| Model: Model K-P2 | Date: 4-Jun-02 | No.: RG073001a |

| Subject: Printer Controller Firmware History | | Prepared by: A. Ishiyama | |

Printer controller firmware history for the Model K-P2 (Kir-P2: G073/G074 model).

User Mode Tree

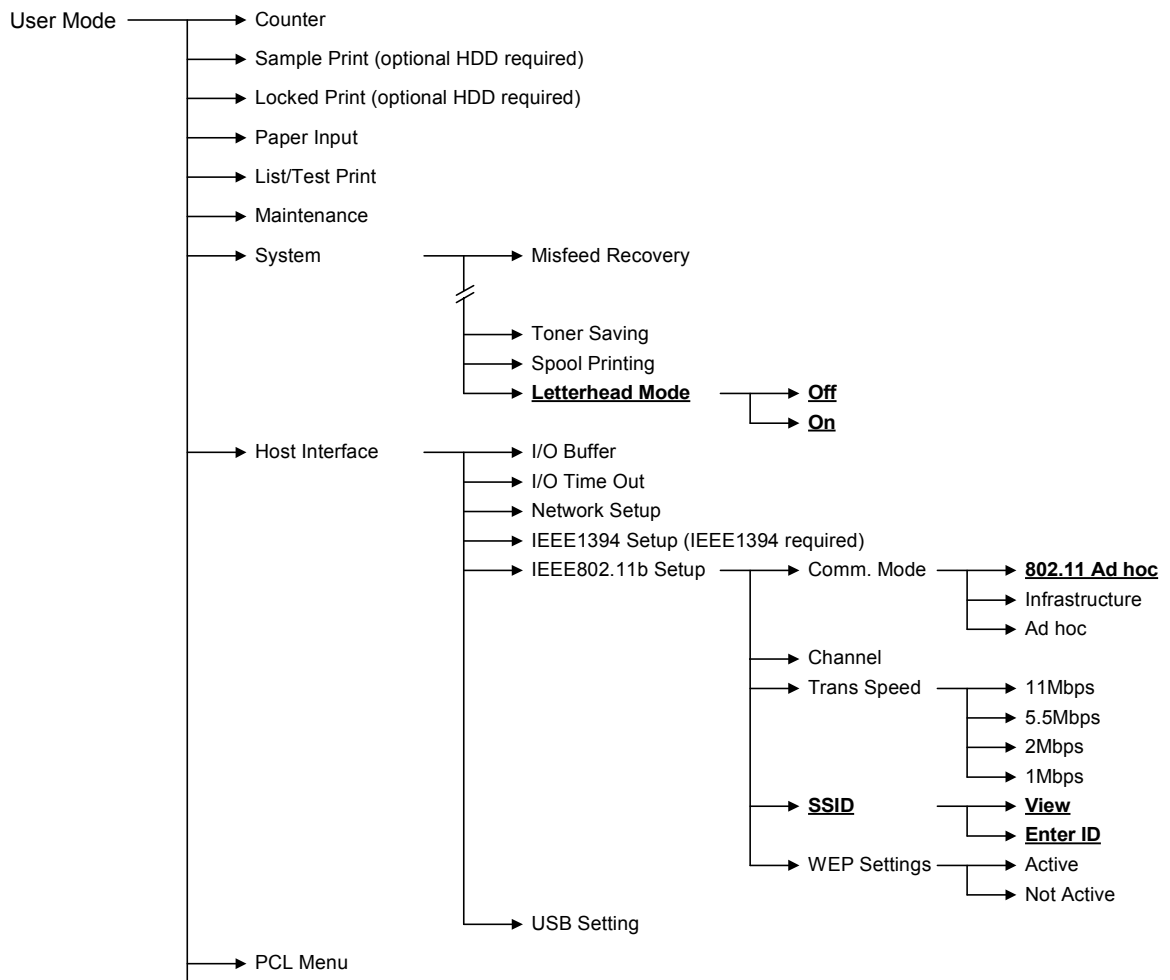
| Descriptions | Version |
|--|-------------|
| <p>New features added to User Mode (see the next page for the User Mode tree):</p> <ol style="list-style-type: none"> Letterhead Mode On: The machine feeds all pages through the duplex unit so that the last page of a job with an odd number of pages is printed onto the front side of the paper. Off (default setting): The last sheet of a job with an odd number of pages is not fed through the duplex unit. Therefore, although the output time of this sheet is slightly faster, the last page is printed onto the rear side. 802.11 Ad hoc mode (one type of Ad hoc mode used with wireless LAN) is supported from this version. SSID (used for infrastructure mode with wireless LAN) can now be programmed from User Mode as well – previously, this was only possible using Web Status Monitor or telnet. 128-bit WEP key (a wireless LAN security feature) is supported from this version. Previous versions supported only 64-bit WEP. | |

Underlined features have been added from version 1.04.

User Mode Tree

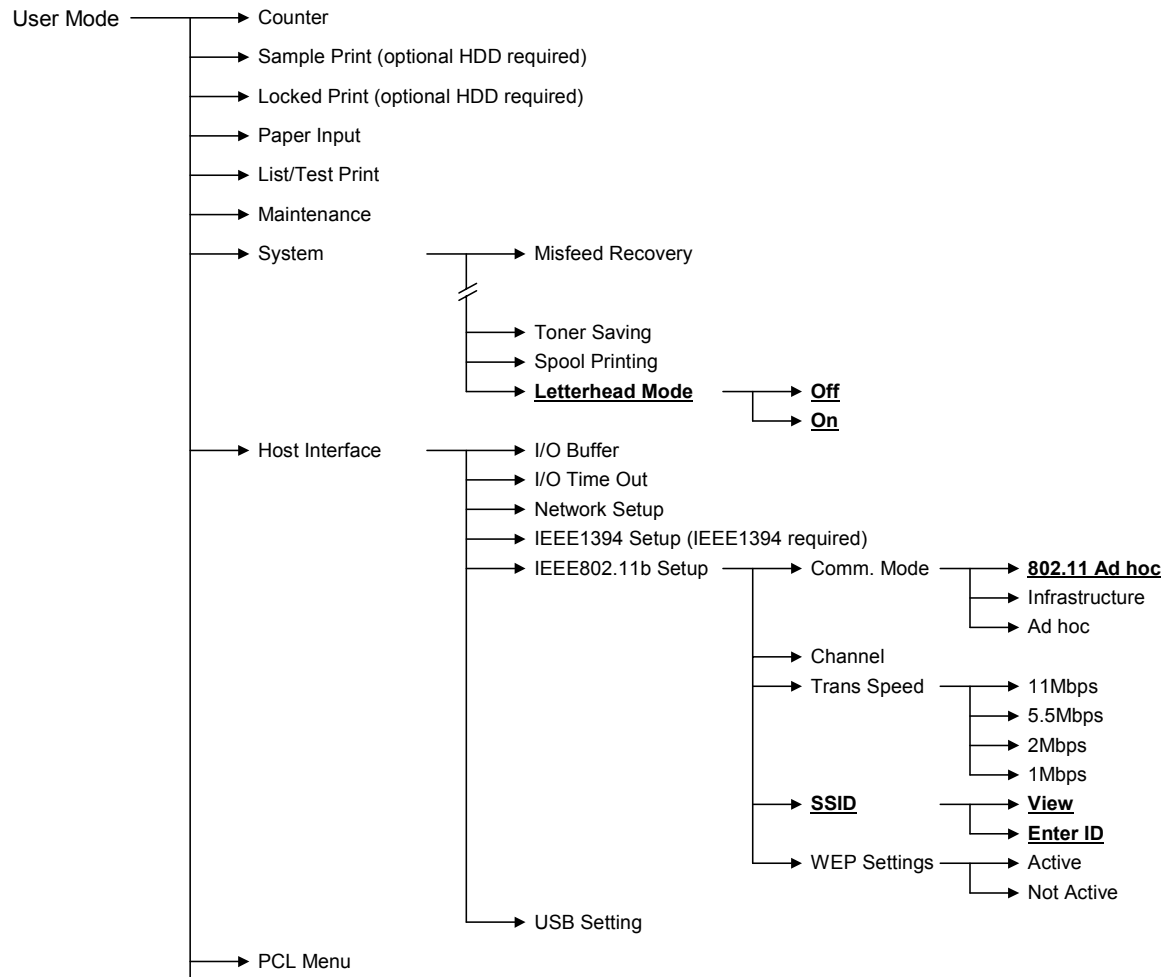
| Model: Model K-P2 | Date: 4-Jun-02 | No.: RG073001c |
|---|----------------|----------------|
| <p>New features added to User Mode (see next page for User Mode tree):</p> <ol style="list-style-type: none"> 1. Letterhead Mode On: The machine feeds all pages through the duplex unit so that the last page of an odd-paged job is printed onto the front side of the paper. Off (default setting): The last sheet of an odd-paged job is not fed through the duplex unit, therefore although the output time of this sheet is slightly faster, the last page is printed onto the rear side. 2. 802.11 Ad hoc mode (one type of Ad hoc mode used with wireless LAN) is supported from this version. 3. SSID (used for infrastructure mode with wireless LAN) can now also be programmed from User Mode. Previously, this was only possible using Web Status Monitor or telnet. 4. 128-bit WEP key (a wireless LAN security feature) is supported from this version. Previous versions supported only 64-bit WEP. | | 1.04 |

Underlined features have been added from version 1.04.

User Mode Tree

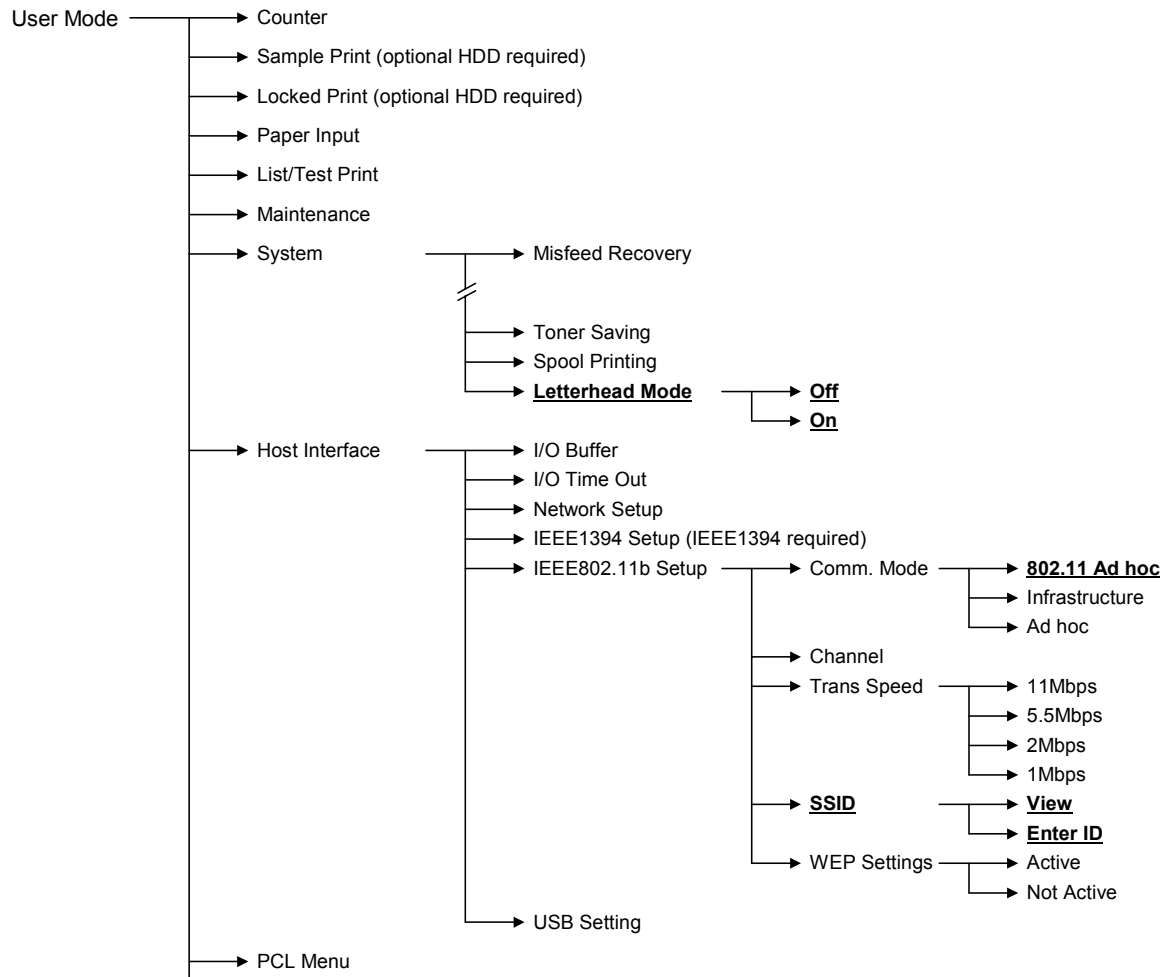
| Model: Model K-P2 | Date: 4-Jun-02 | No.: RG073001d |
|---|----------------|-----------------------------------|
| <p>New features added to User Mode (see next page for User Mode tree):</p> <ol style="list-style-type: none"> 1. Letterhead Mode On: The machine feeds all pages through the duplex unit so that the last page of an odd-paged job is printed onto the front side of the paper. Off (default setting): The last sheet of an odd-paged job is not fed through the duplex unit, therefore although the output time of this sheet is slightly faster, the last page is printed onto the rear side. 2. 802.11 Ad hoc mode (one type of Ad hoc mode used with wireless LAN) is supported from this version. 3. SSID (used for infrastructure mode with wireless LAN) can now also be programmed from User Mode. Previously, this was only possible using Web Status Monitor or telnet. 4. 128-bit WEP key (a wireless LAN security feature) is supported from this version. Previous versions supported only 64-bit WEP. | | <p>1.04</p> |

Underlined features have been added from version 1.04.

User Mode Tree

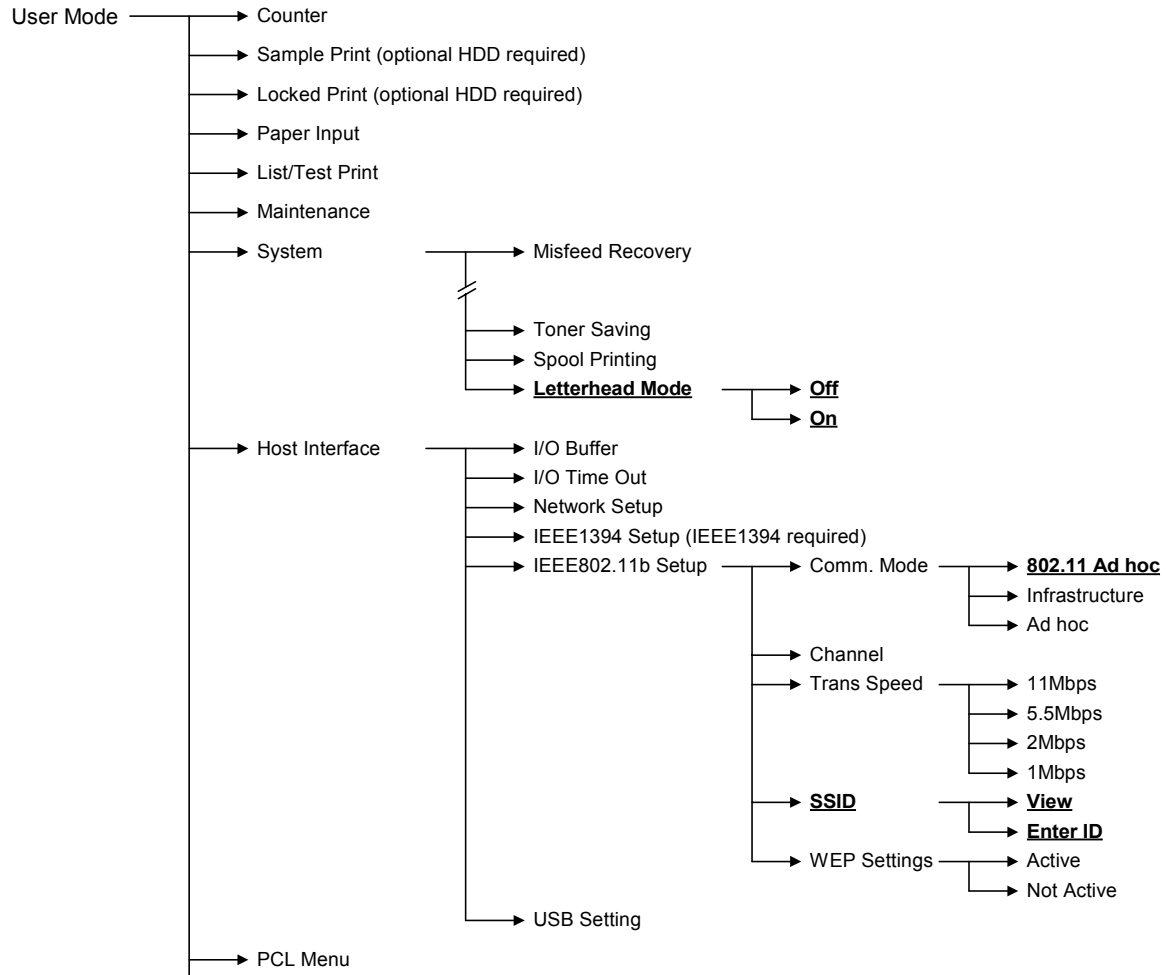
| Model: Model K-P2 | Date: 4-Jun-02 | No.: RG073001e |
|---|----------------|----------------|
| <p>New features added to User Mode (see next page for User Mode tree):</p> <ol style="list-style-type: none"> 1. Letterhead Mode On: The machine feeds all pages through the duplex unit so that the last page of an odd-paged job is printed onto the front side of the paper. Off (default setting): The last sheet of an odd-paged job is not fed through the duplex unit, therefore although the output time of this sheet is slightly faster, the last page is printed onto the rear side. 2. 802.11 Ad hoc mode (one type of Ad hoc mode used with wireless LAN) is supported from this version. 3. SSID (used for infrastructure mode with wireless LAN) can now also be programmed from User Mode. Previously, this was only possible using Web Status Monitor or telnet. 4. 128-bit WEP key (a wireless LAN security feature) is supported from this version. Previous versions supported only 64-bit WEP. | | 1.04 |

Underlined features have been added from version 1.04.
